Part 5 Application **ACCESS REPORT**

Reference Number: 23380

10 Lagoon Street and 75-77 Murray
Street, Moruya, NSW

This Access Compliance Report is to accompany a Part 5 application for the development proposed at **10 Lagoon Street and 75-77 Murray Street, Moruya, NSW.**

Adaptable unit location shown in blue above and the Livable housing units location shown in yellow above.

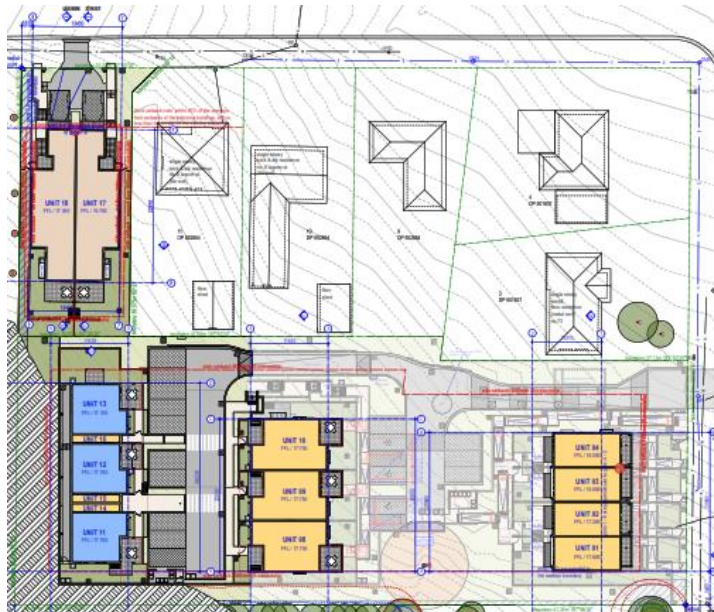
The Council requires 25% of Adaptable units to a **Class C** level and therefore 5 adaptable units are required to be provided in the development. However, Client has accepted provision of 3 adaptable units in the development on the basis that townhouses 1 to 4 are designed to achieve compliance with LHA Silver Livable.

[Image description: Plan of Level 00 above shows the provision of Accessible parking spaces]

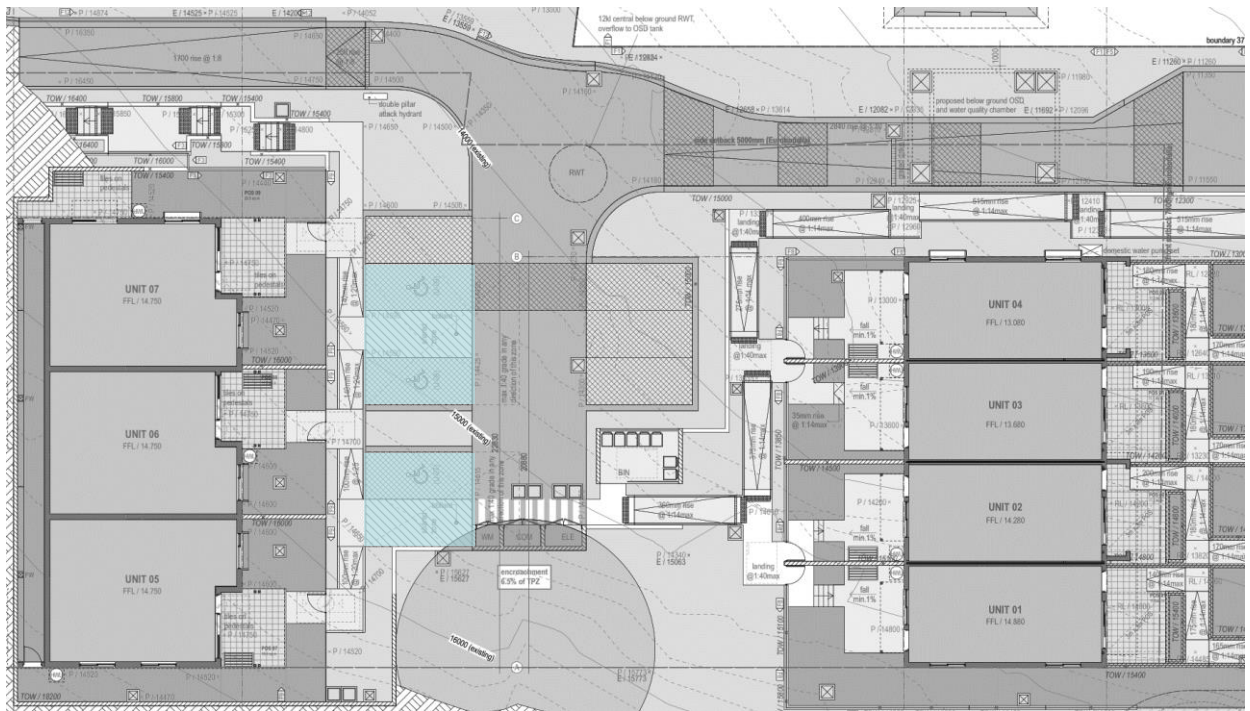
Eurobodalla Shire Council requires provision of 25% Adaptable units in the development. Development has total number of 18 units. $25\% \text{ of } 18 = 4.5 = 5$ required Adaptable units. However, Client has accepted provision of 3 adaptable units in the development as far as Units 1 to 4 are designed to achieve Silver livable compliance.

Therefore, 3 accessible carparking spaces are required for the residential component of the development.

3 Accessible car parking spaces have been provided in development.

One accessible parking space is required to be allocated to each of the Adaptable units.

Pre-adaptation layout

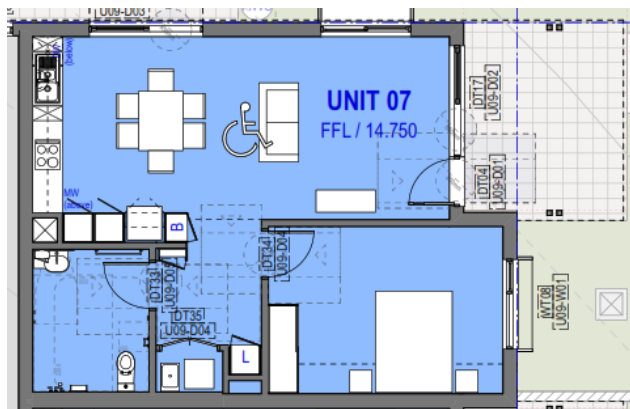
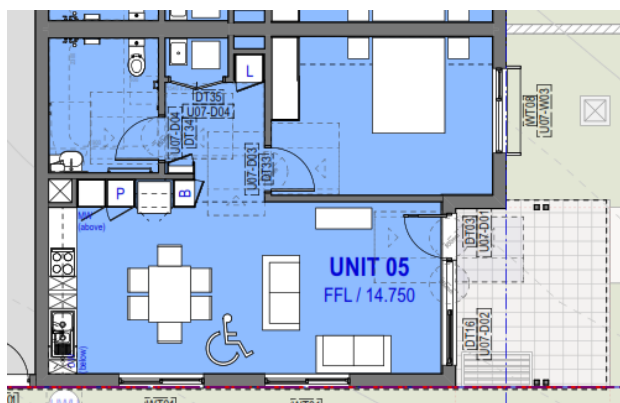
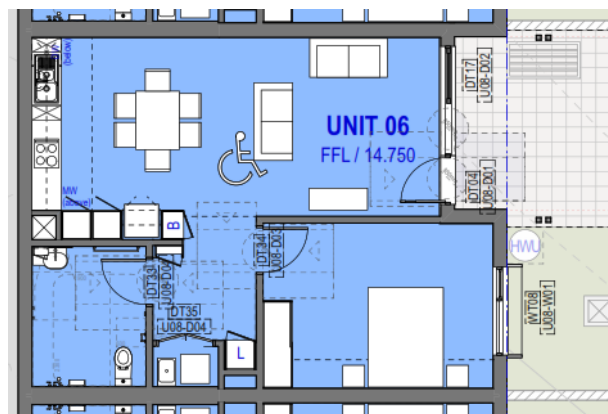
3 Adaptable units are required by the Council's DCP to a **Class C** level.

The units designated as adaptable are unit numbers 05, 06 & 07.

Units – 1 to 4 (ground floor level)

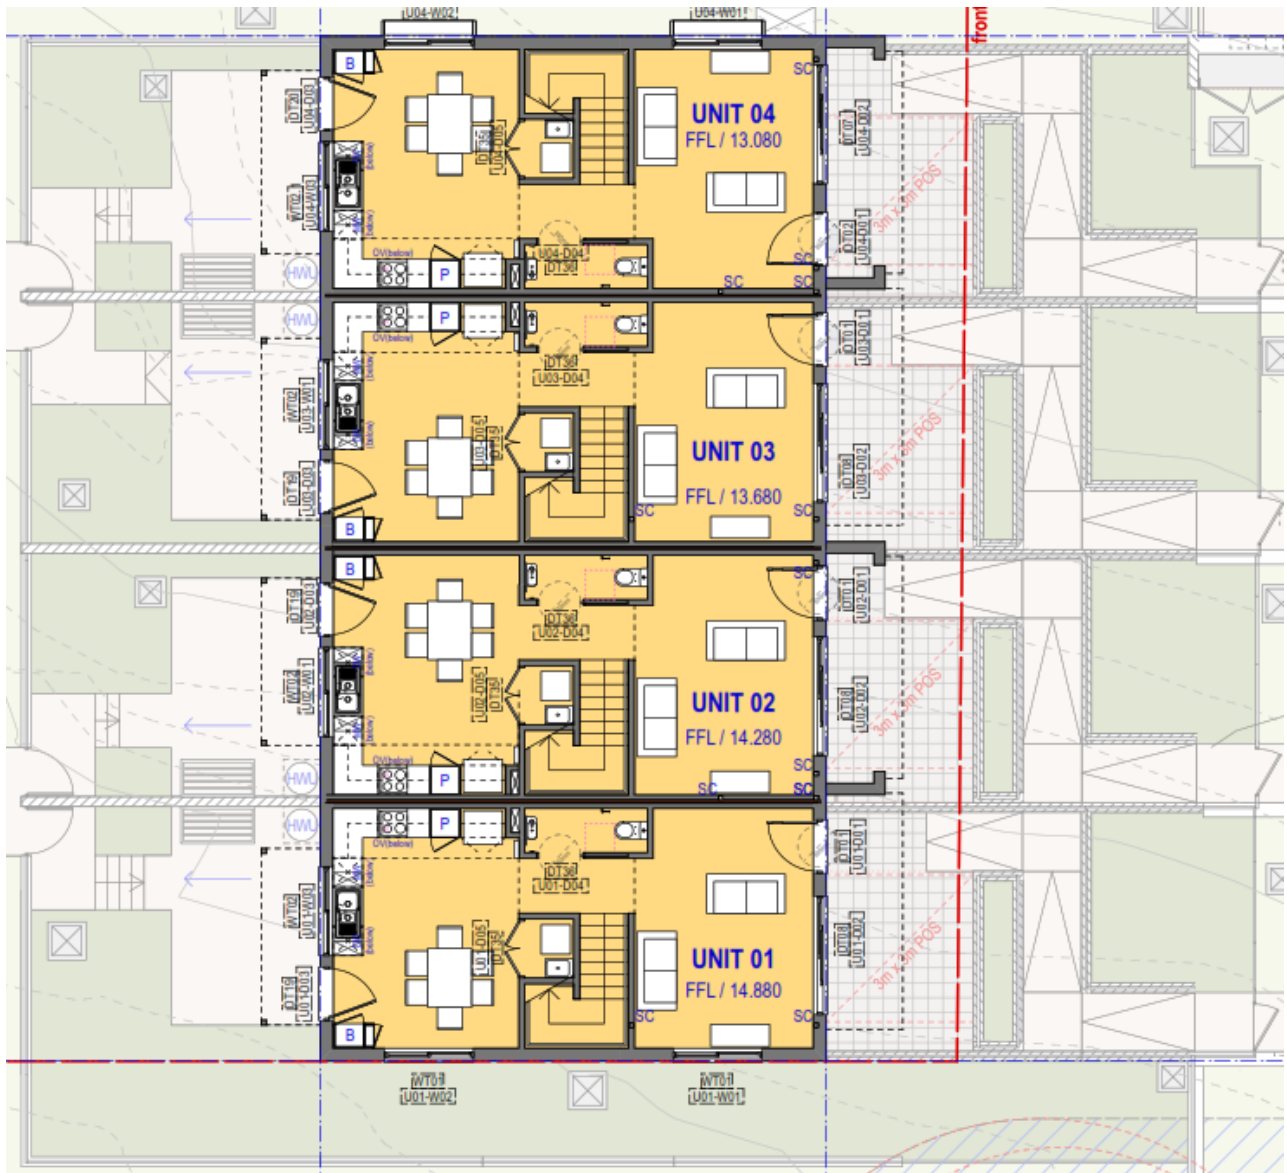
Access from site boundary is via 1:14 grade.

A clear space of 1200x1200 is to be achieved clear of the gate swing to the start of the ramp
